Site Accessibility Evaluation

The National Fallen

Firefighters Memorial

SUBJECT: Memorial Park International Firefighters Memorial Self-Evaluation

Image of access aisle with excessive cross slope

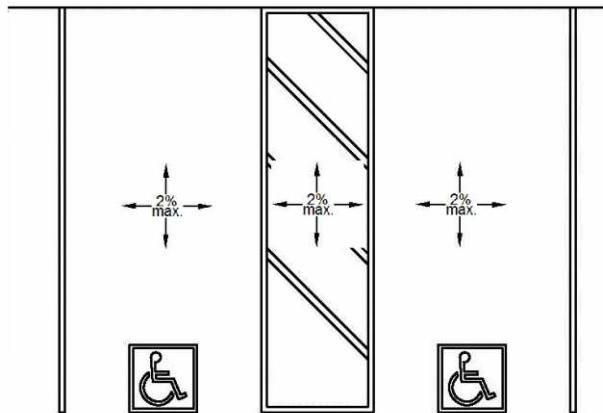
Finding: 1

The cross slope (short dimension) of the access aisle exceeds 2%.

The cross slope in the access aisle on the left is up to 4%.

Remove and replace the asphalt to provide maximum 2% cross slope.

Image of access aisle with excessive cross slope

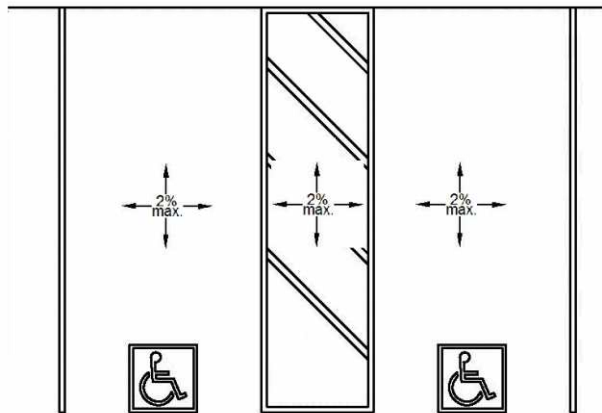
Finding: 2

The cross slope (short dimension) of the access aisle exceeds 2%.

The cross slope of the access aisle on the right is up to 3%.

Remove and replace asphalt to provide maximum 2% cross slope.
